ADDENDUM NO. 2

HELENA FIRE STATION #3

PROJECT: Helena Fire Station #3
Helena, Montana

ARCHITECT: DOWLING Architects
734 North Last Chance Gulch
Helena, MT 59601
406-457-5470

10 PRIVATE BATHROOM COUNTER
1 1/2" = 1'-0"

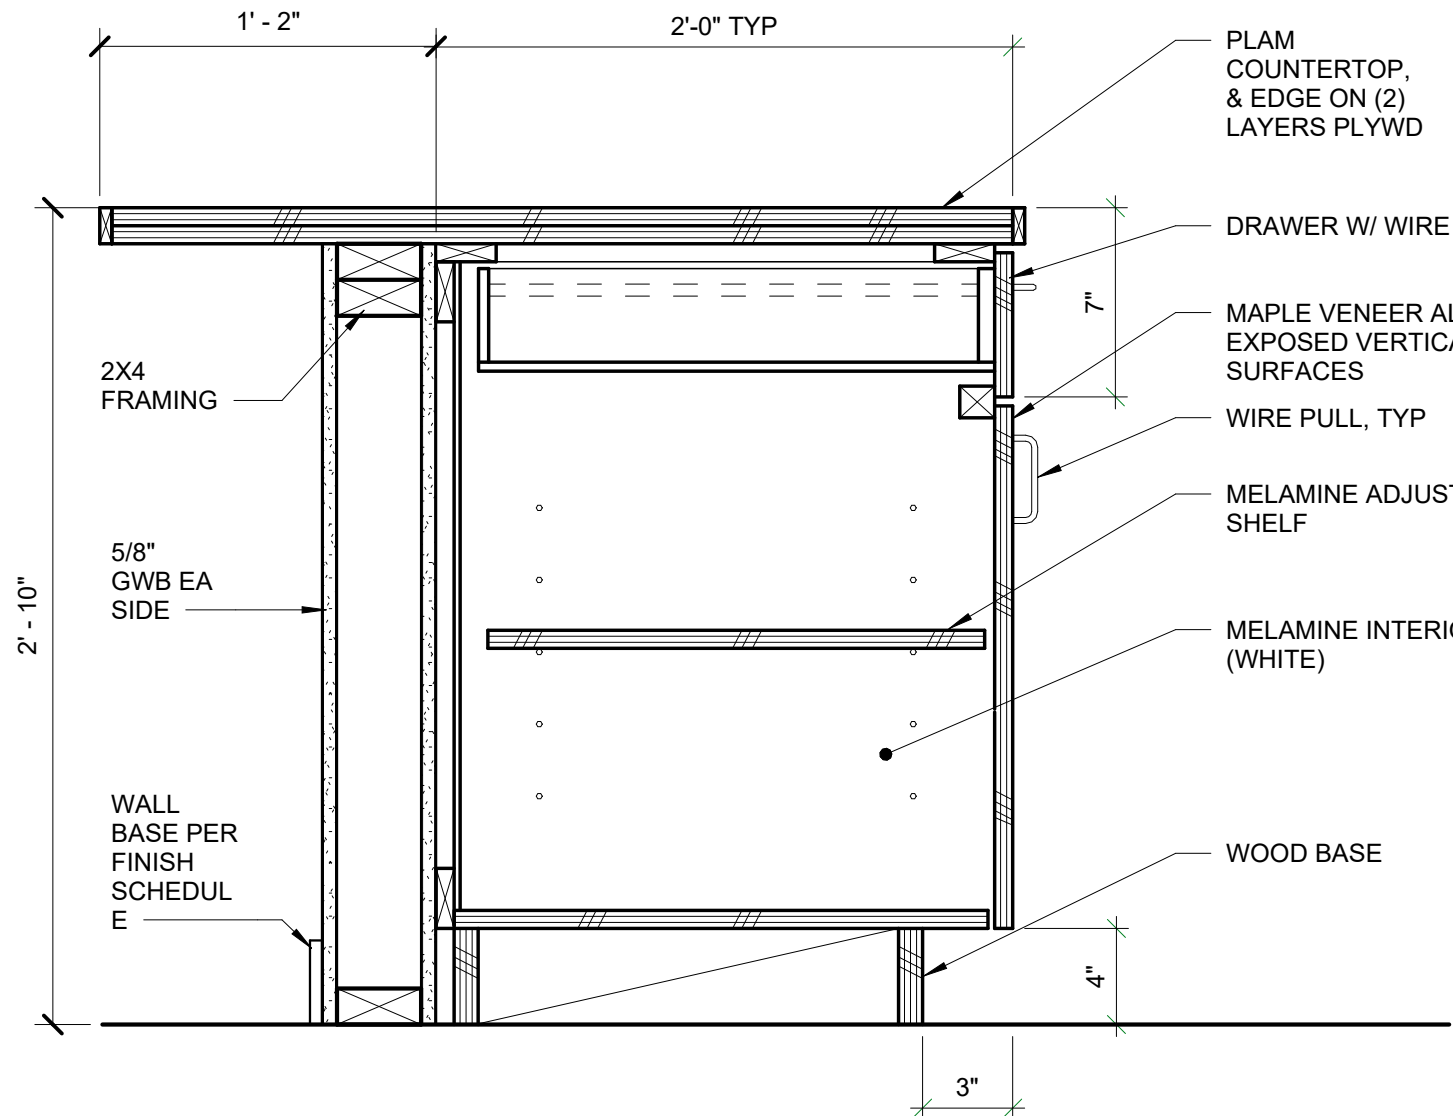
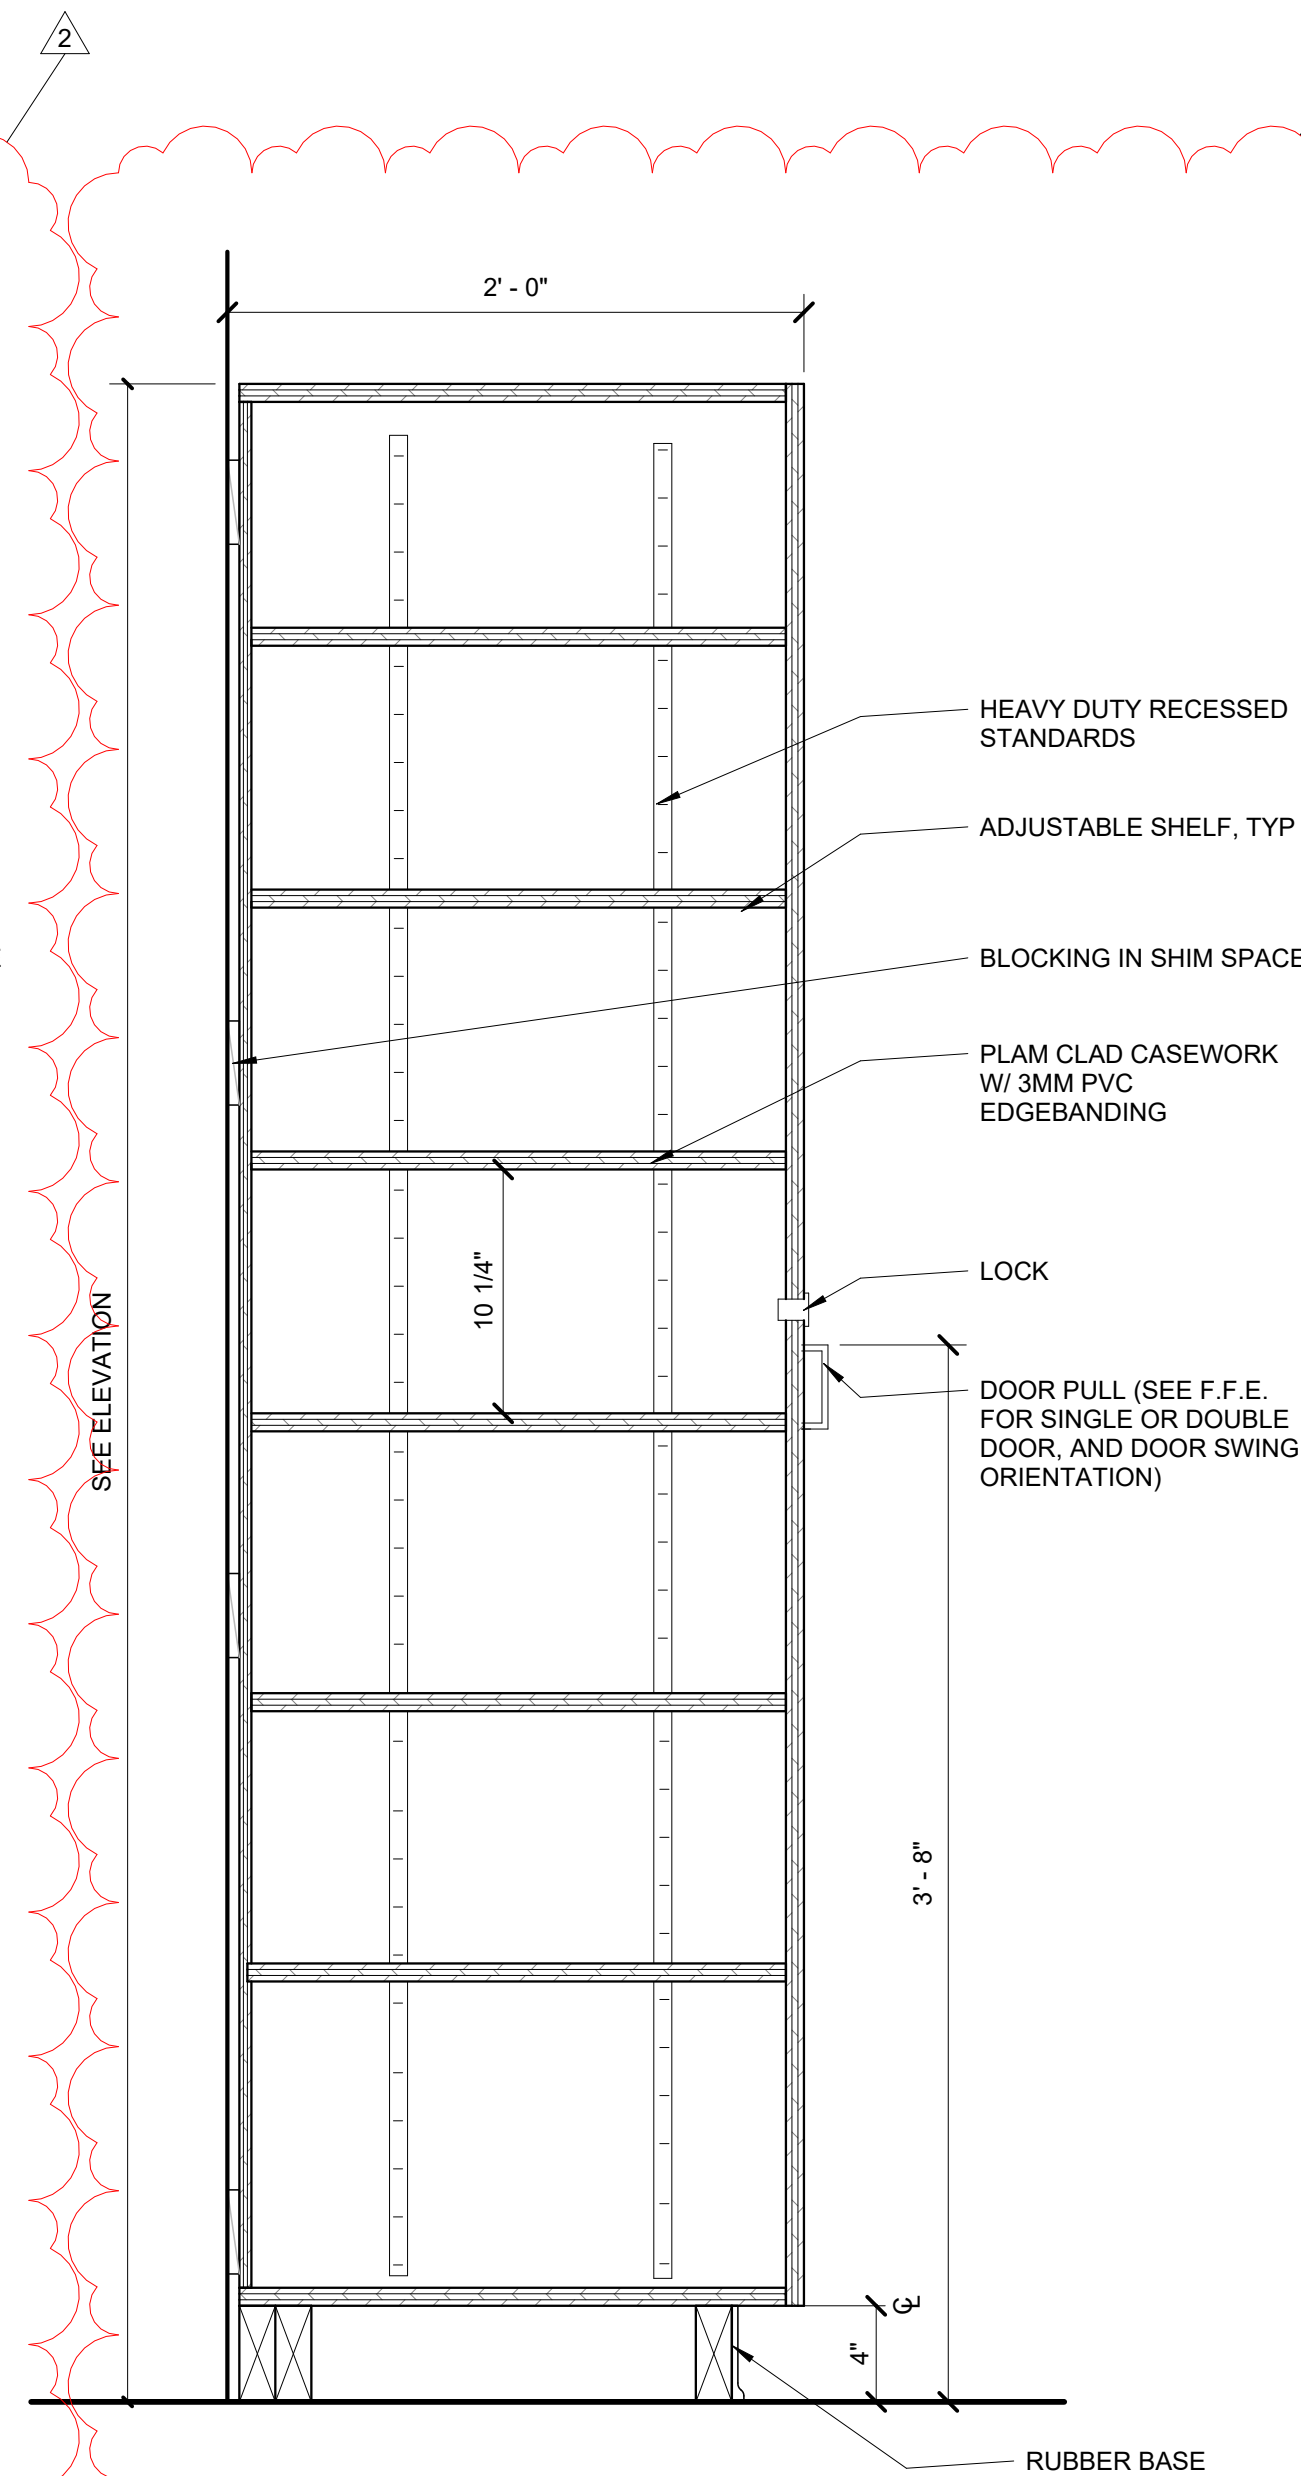
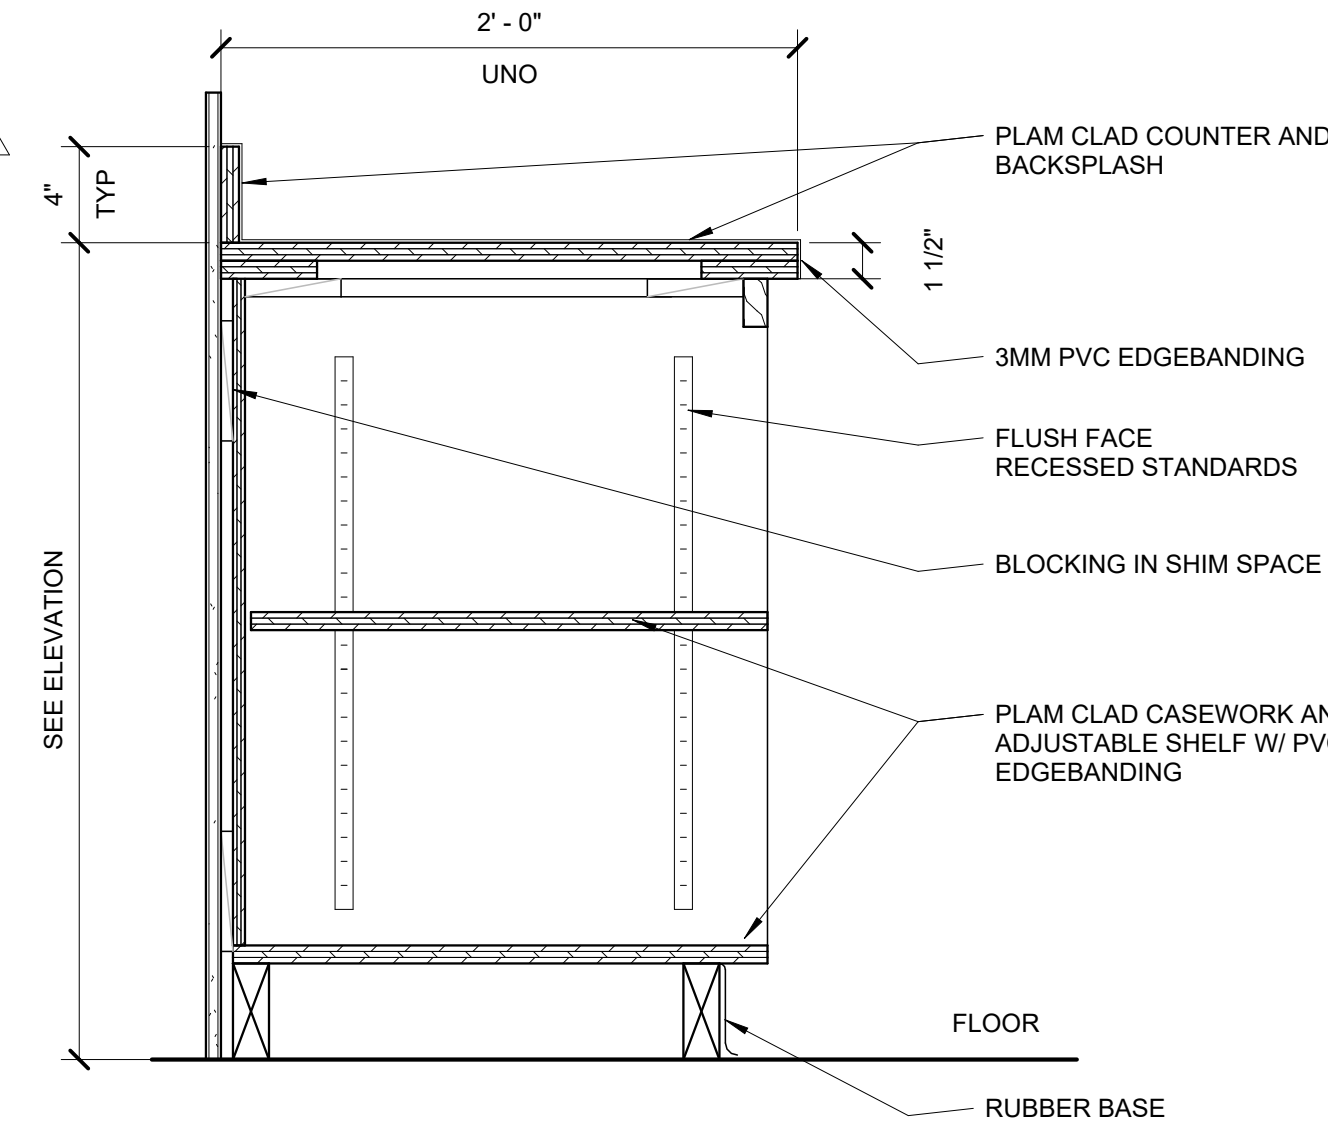
- **Sheet A 7-6- Interior Elevations:** Revised note regarding Cement Fiber Board to more directly specify product.
- **Sheet A7-7 Casework-** Added casework detail for bathroom 124&125 to show the sink & counter top condition, as well as added typical taller casework drawings (cabinets/dorm lockers)

ENLARGED
SITE AND
UTILITY PLAN

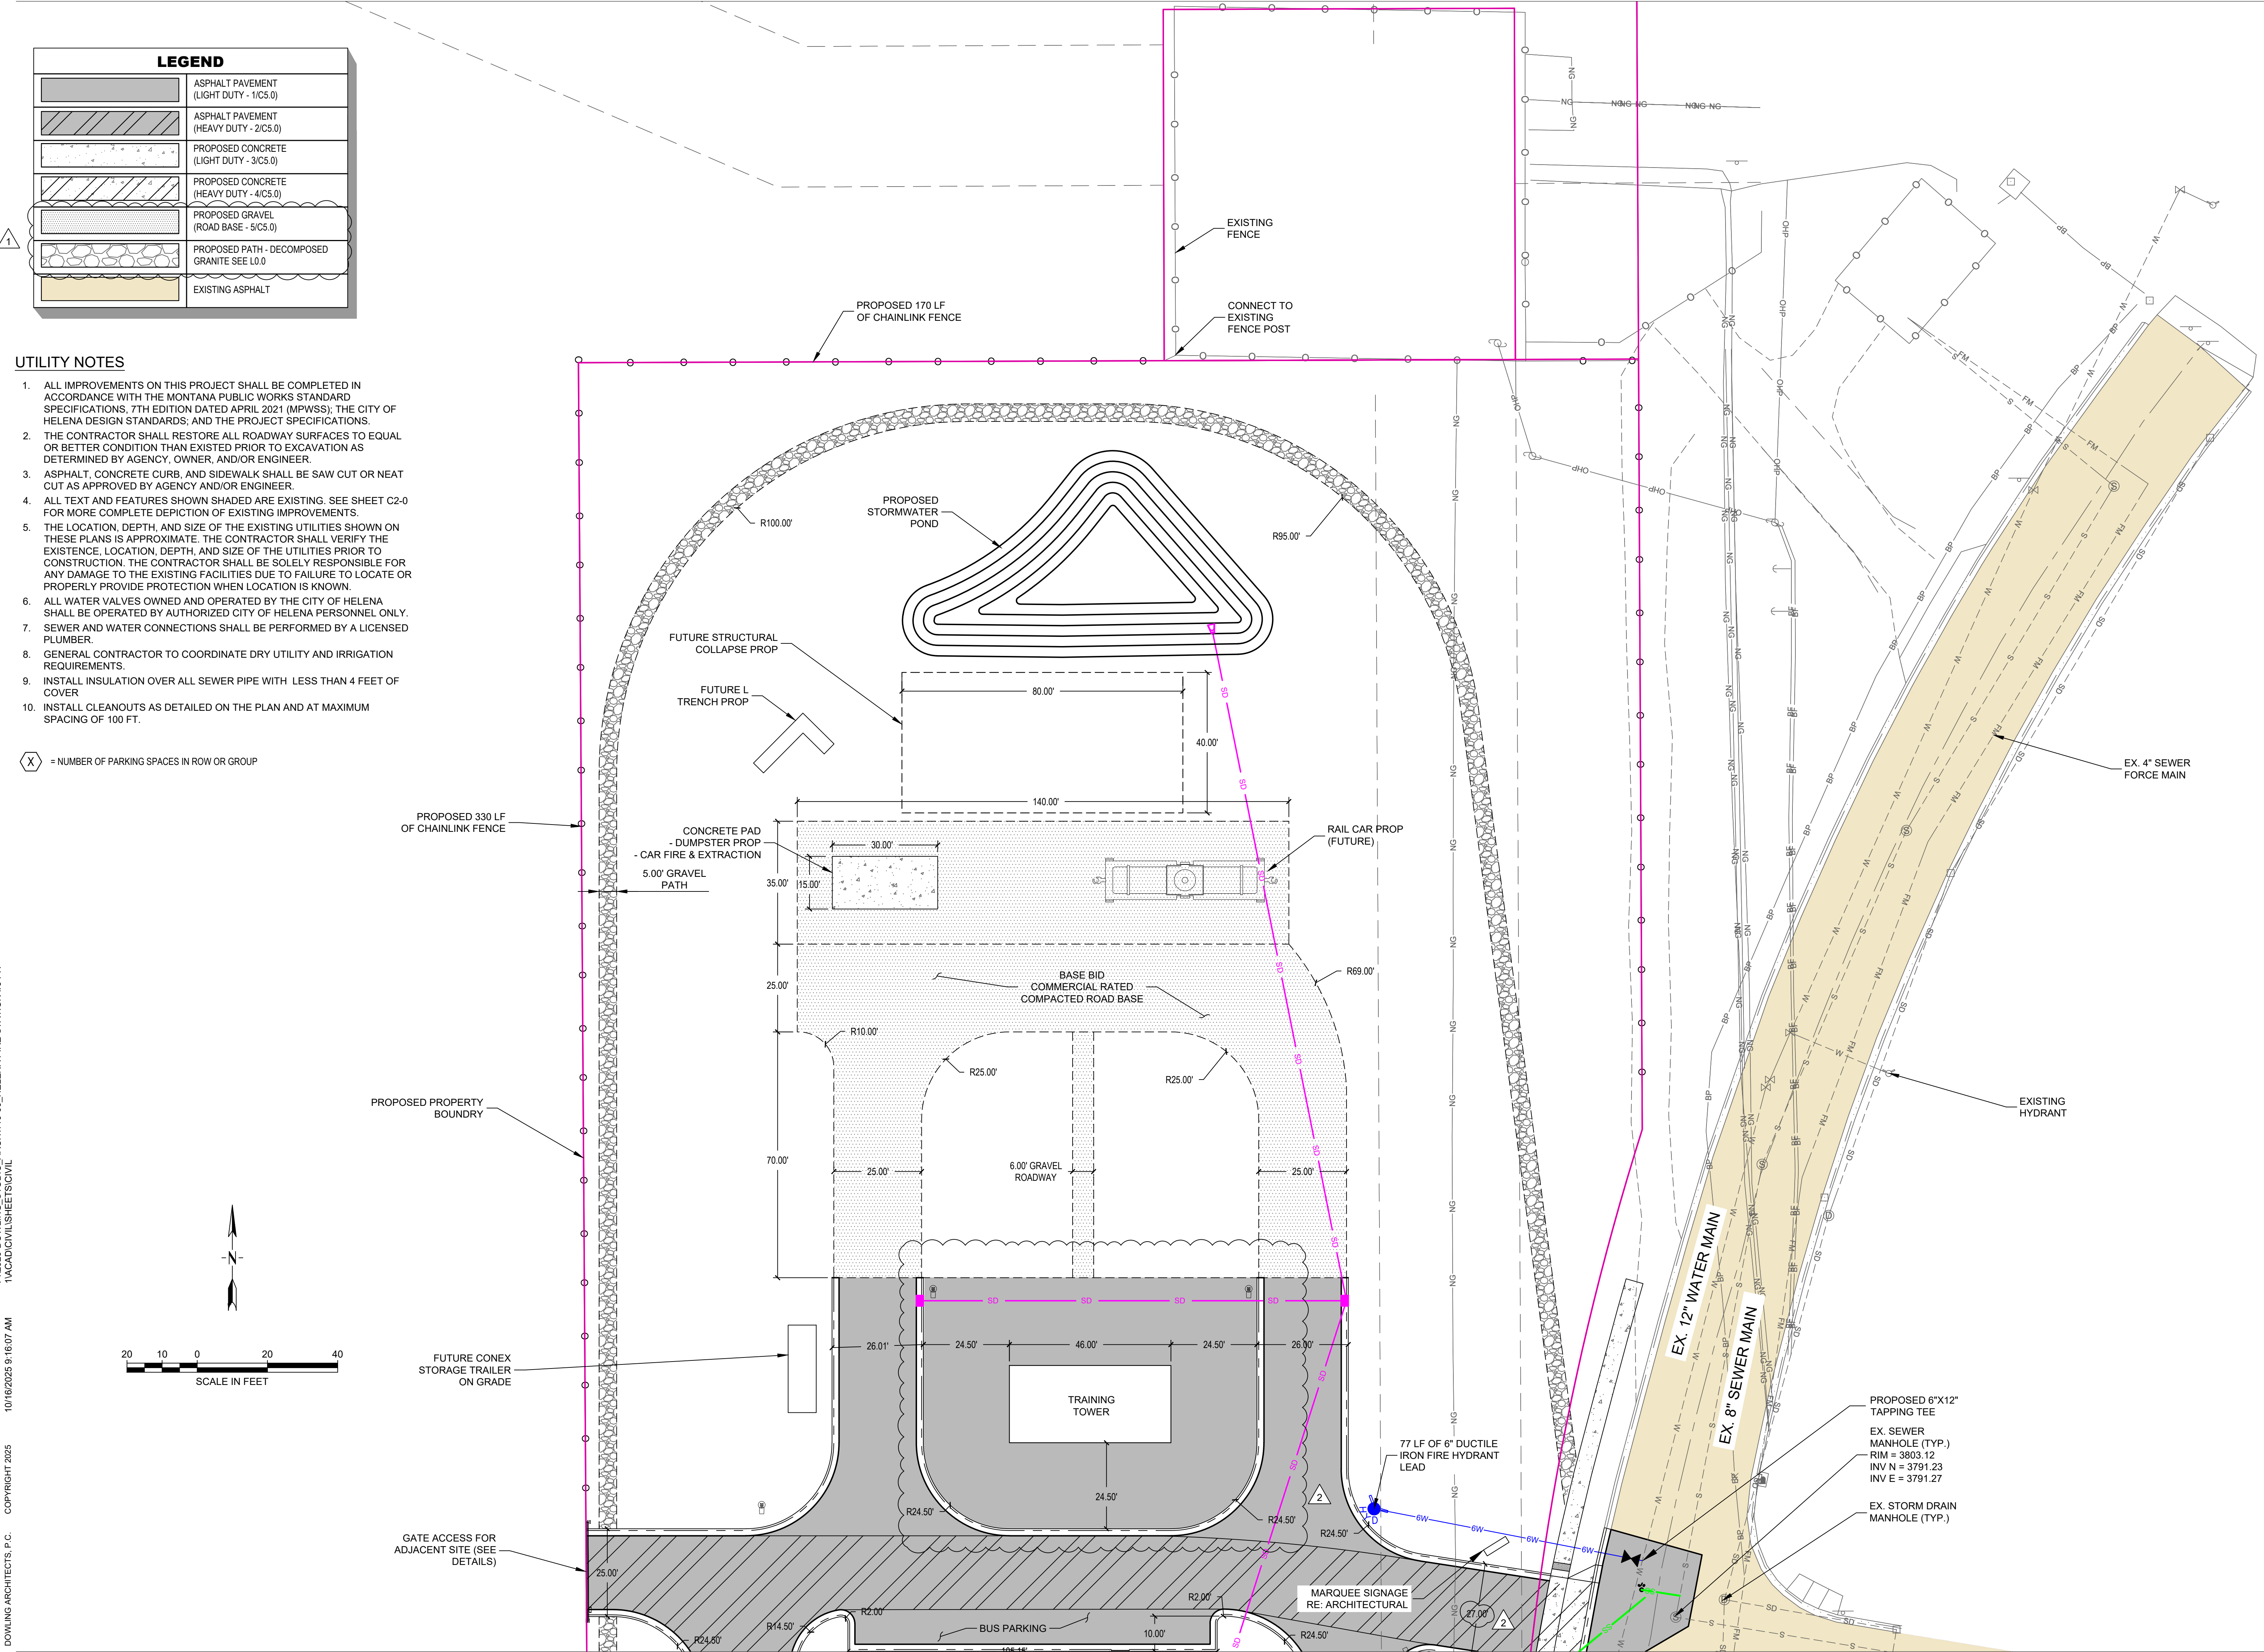
- **Sheet C3-1 Enlarged Site and Utility Plan** – Widened drive aisle per truck turning movements, Revised area around training tower from concrete to asphalt.
